Burk's Falls West Solar Project

Modification Document – Proposed Relocation of Stormwater Diversion Channel

H353720-00000-121-066-0001

Figure 1-1
 Northland Power Inc.
Burk's Falls West Solar Project
Water Body and Project Boundaries
HATCH

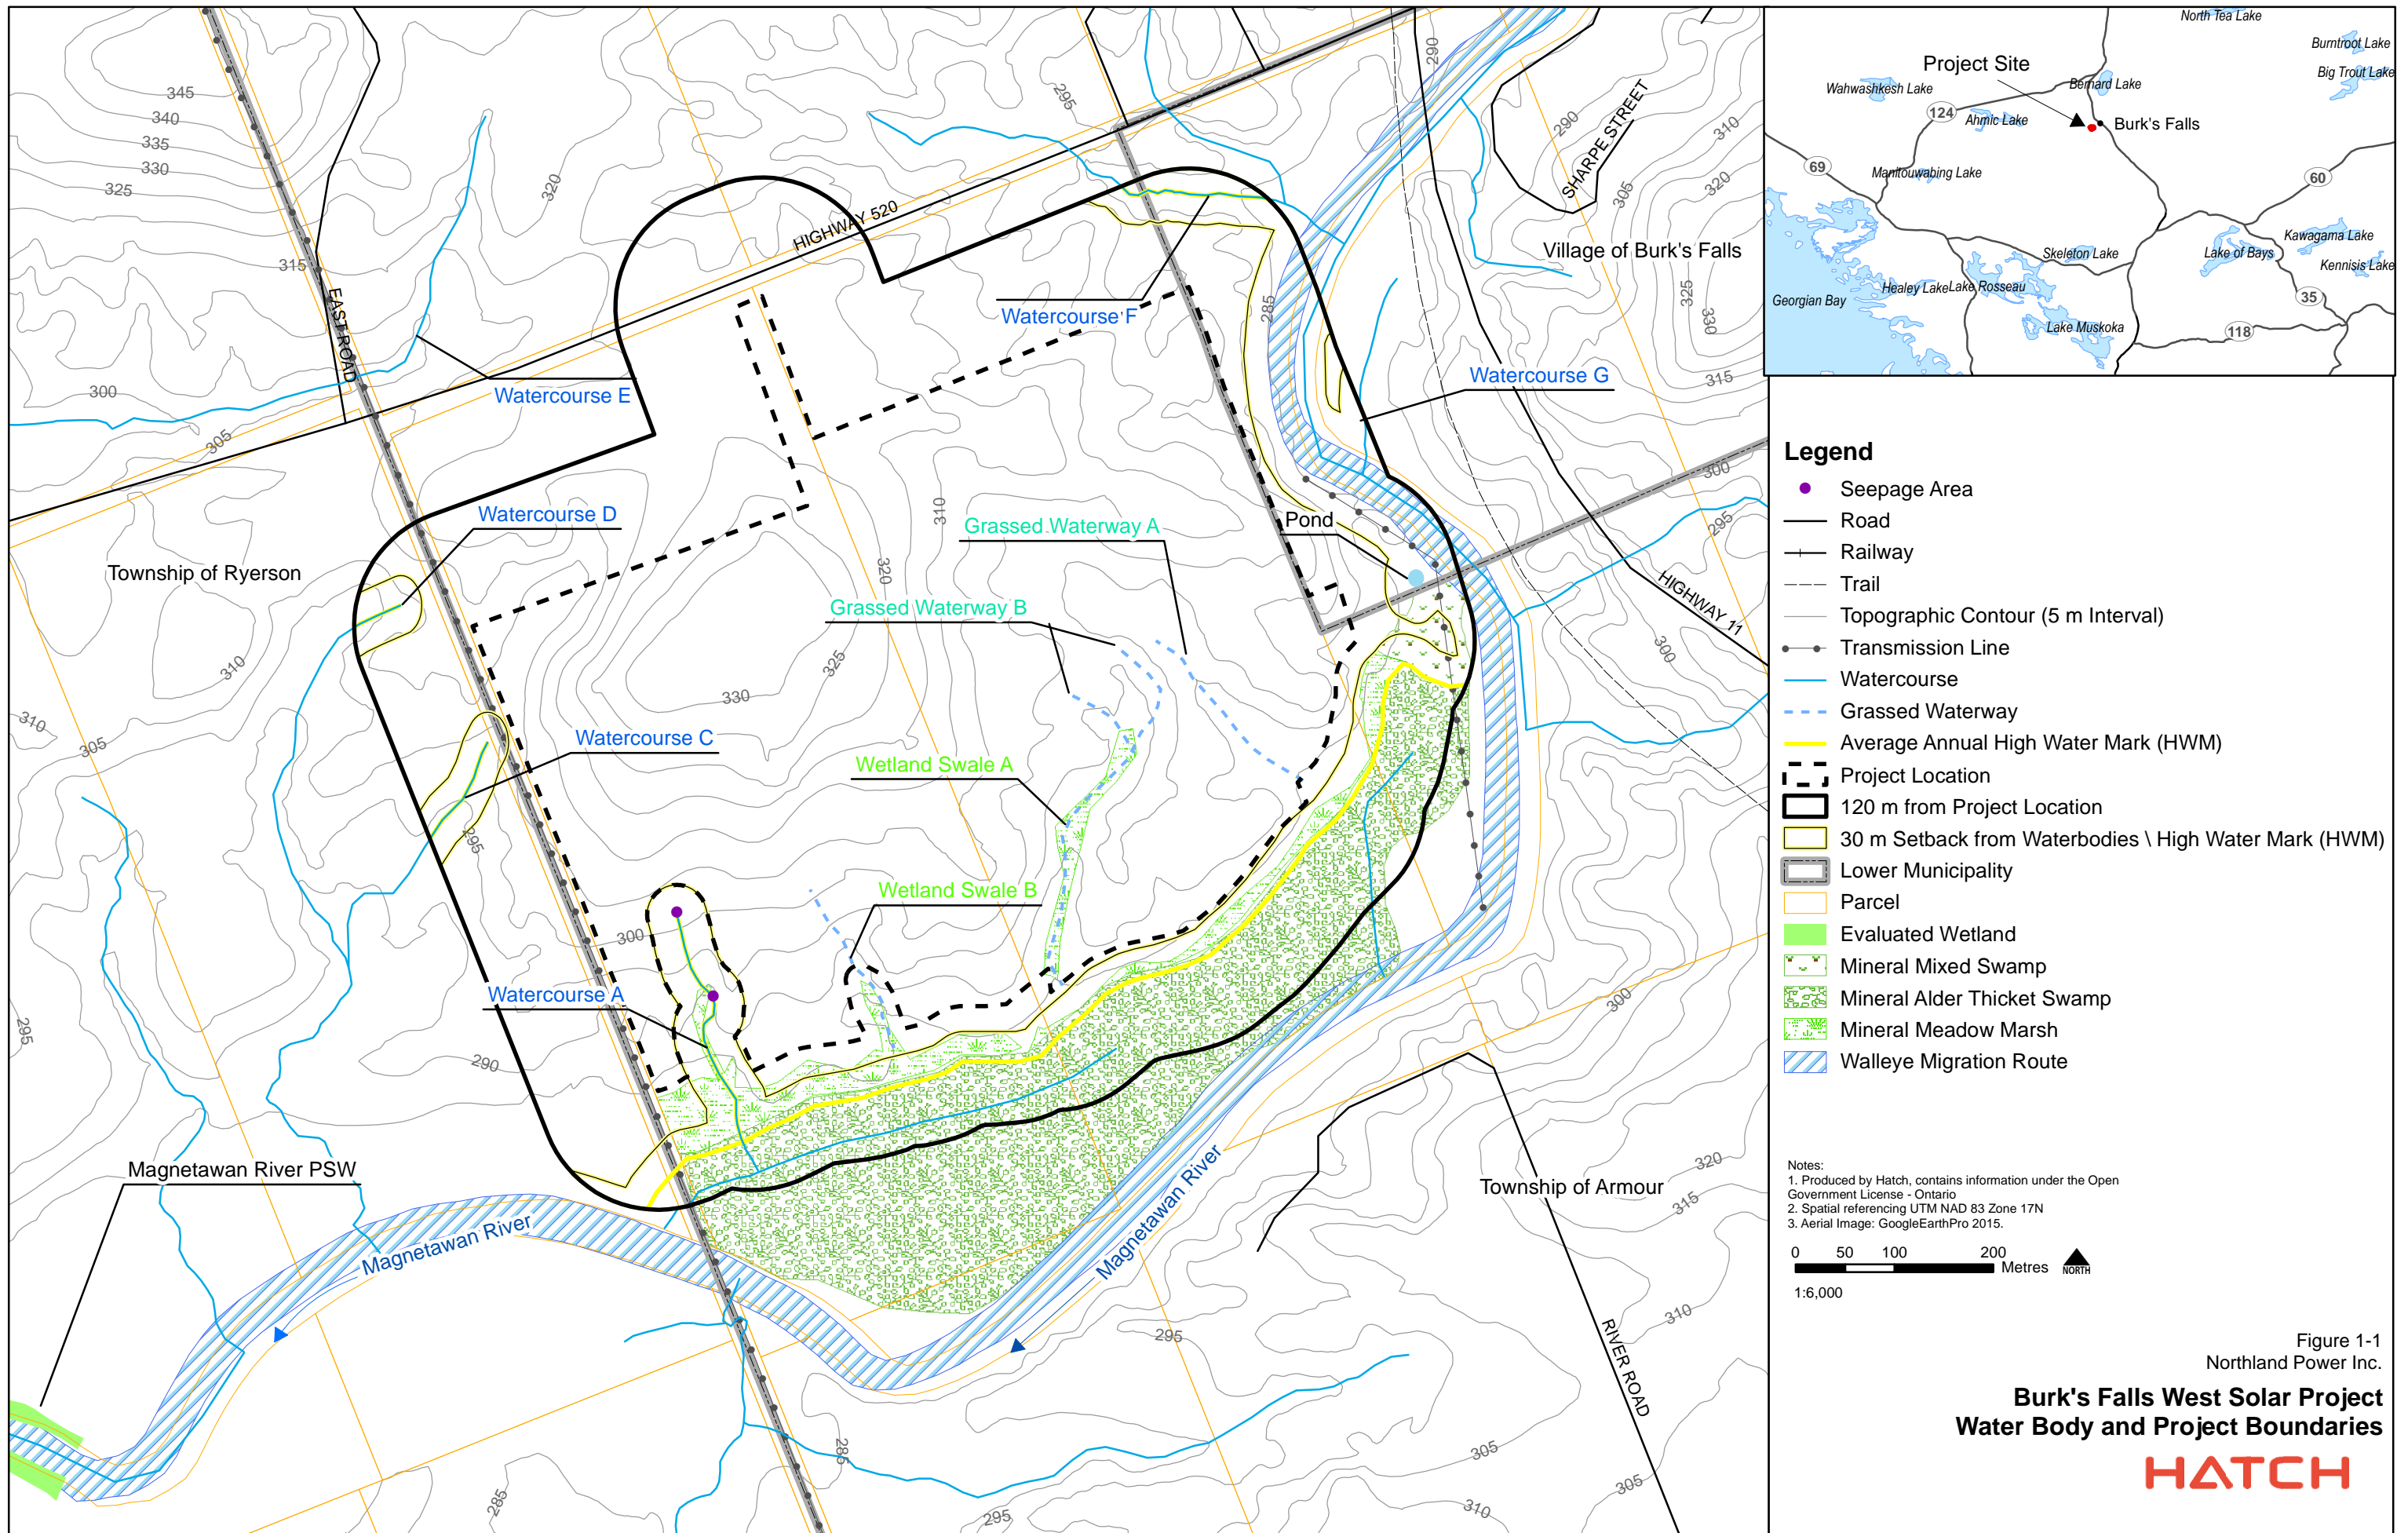
Attachment 1 contains the original site plan, while Attachment 2 contains a proposed revised site plan.

Change	Rationale for Change	Altered Effect	Additional Mitigation Required	Additional Environmental Effects Monitoring
Relocation and extension of a stormwater drainage channel	To reduce surface waters entering an area of unstable soils beneath a substation that are currently shifting	Minor alteration in boundary of Project location. Potential adverse effects include encroachment into surrounding natural heritage features as well as the encroachment into a watercourse 30 m setback.	None Required. Originally proposed mitigation measures will be maintained. Attachment 3 discusses in detail.	None required

Revised Project Location Figure

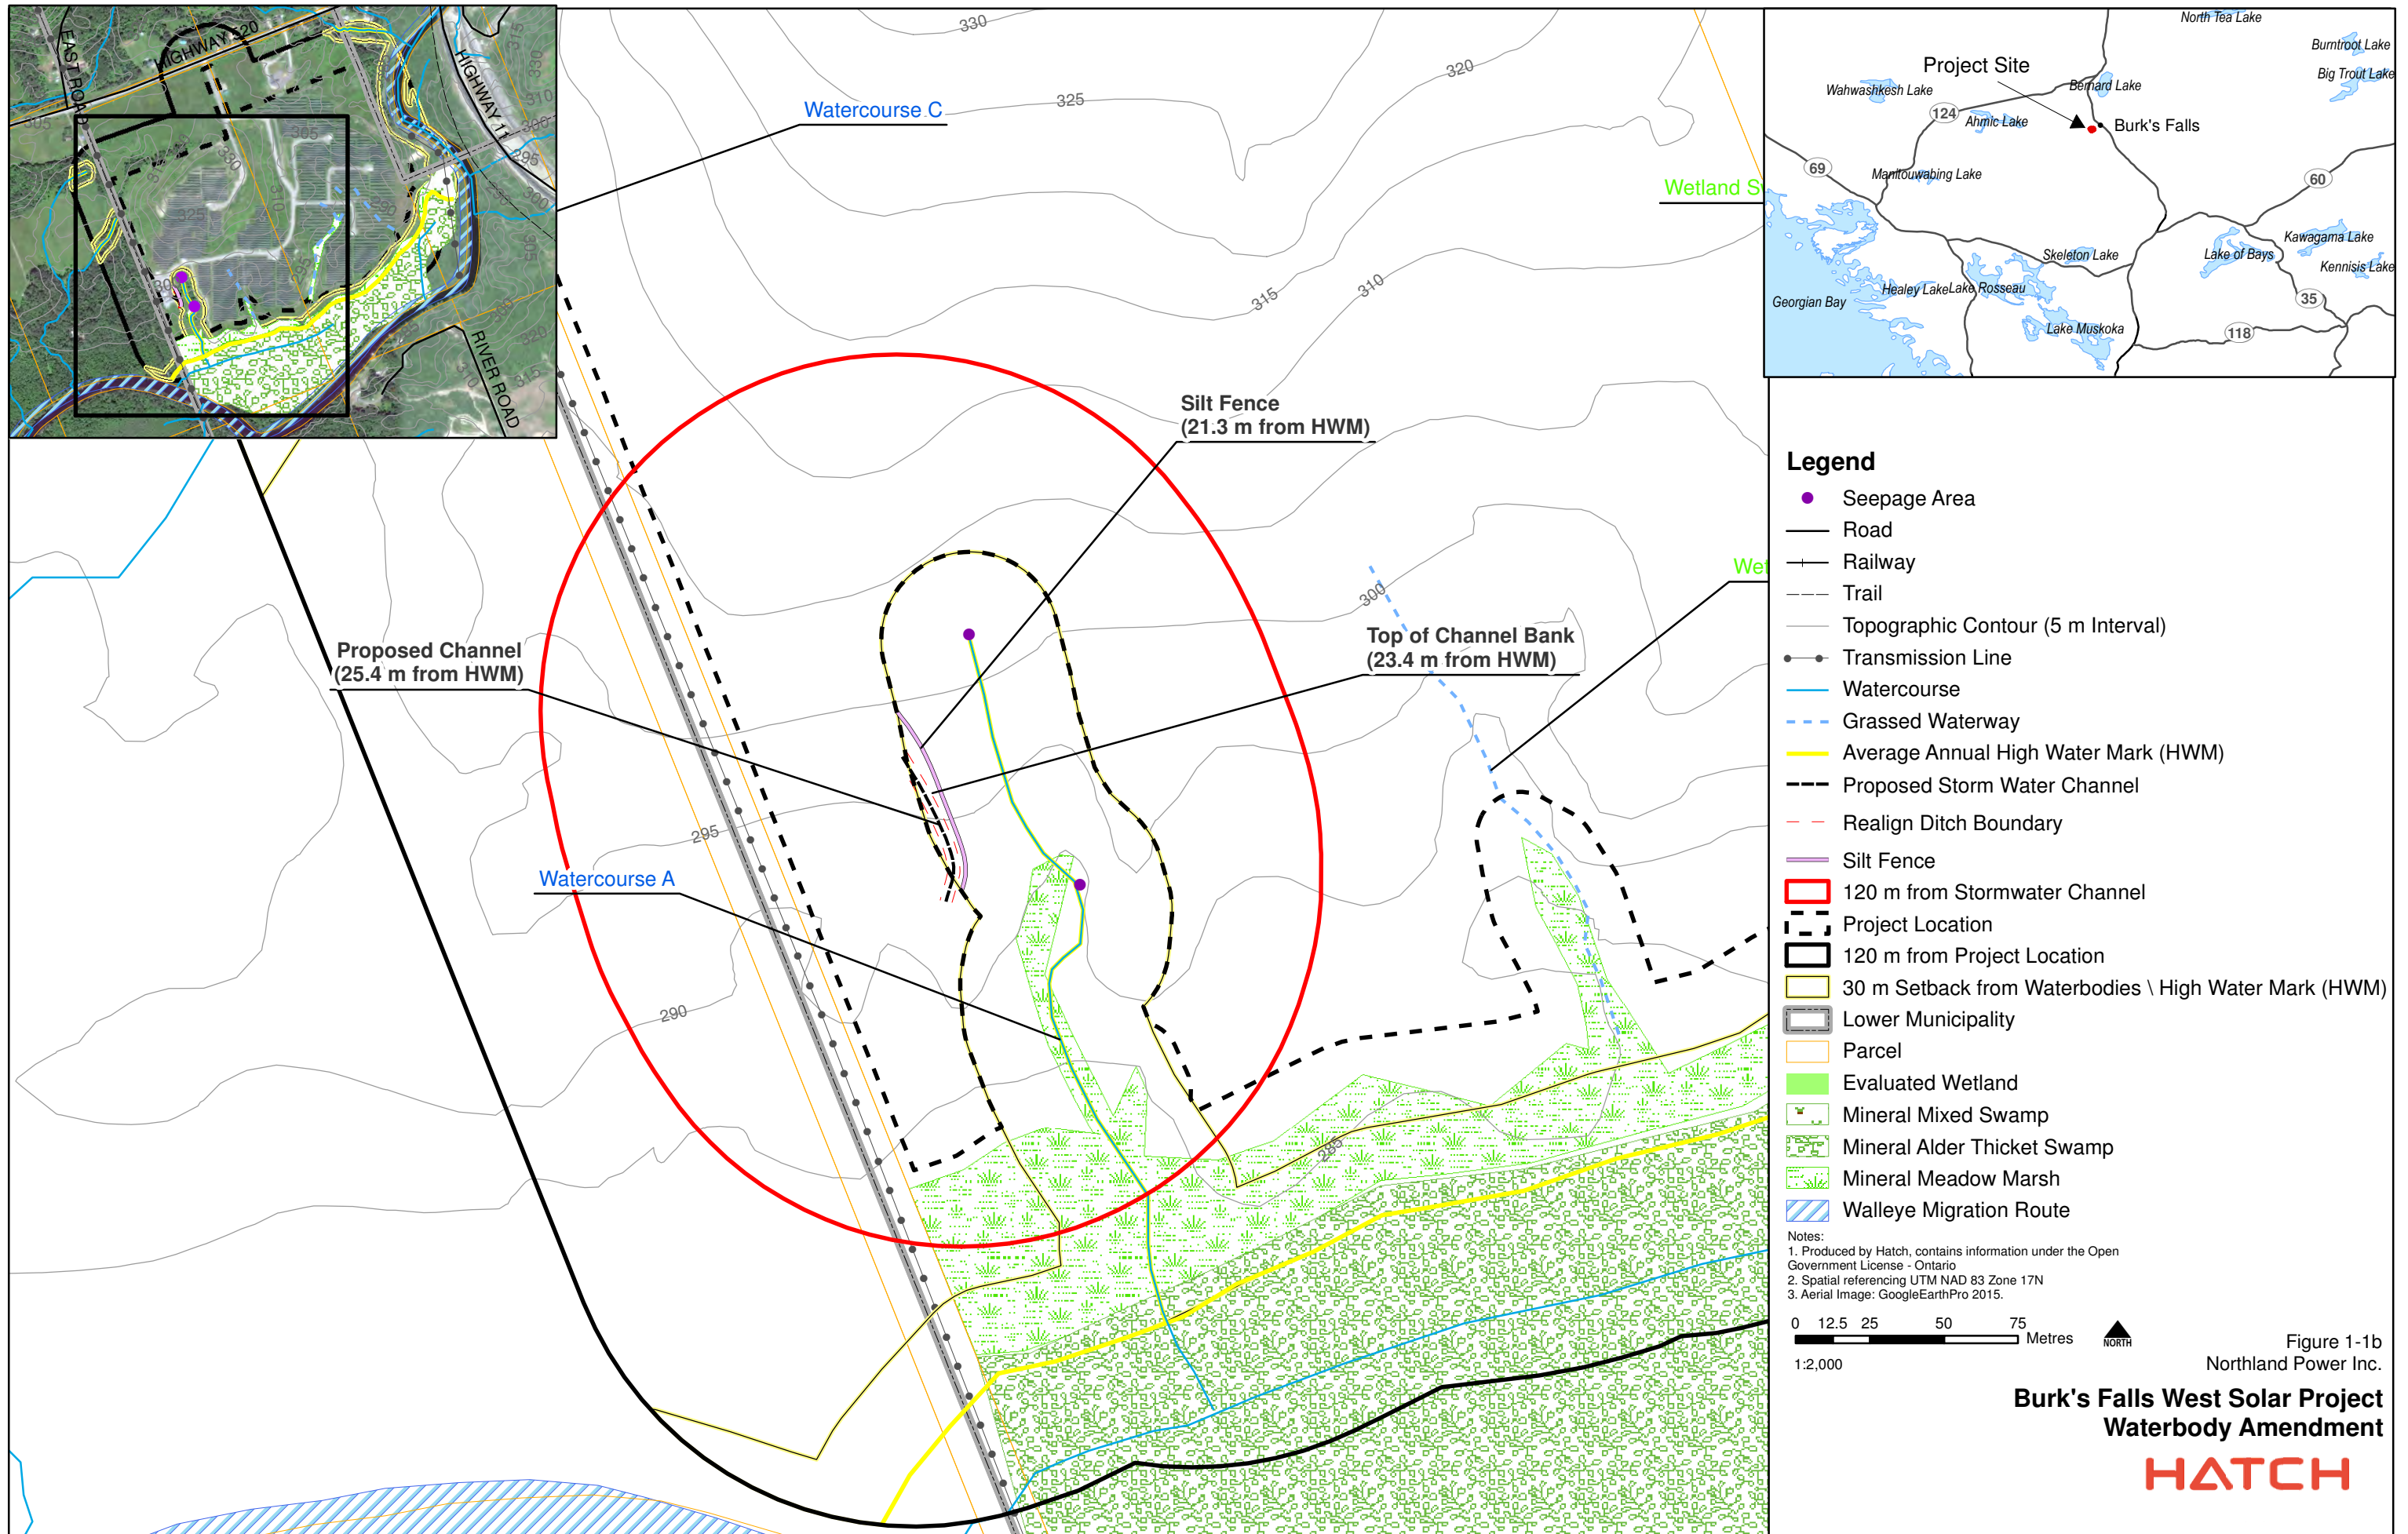
No additional solar module, inverter or transformer installation is proposed; existing Project infrastructure will be utilized for access to the proposed channel. See Figure 1-1b (Revised Project Location) attached.

thereby maintaining a 23.4 m setback from the watercourse (Figure 1-1b). To complete the channel, approximately 204 m² of existing soils would be shaped, stabilized with rip/rap stone and revegetated; the discharge is not within a watercourse and as such, sediment or hydrology concerns are mitigated during storm events.
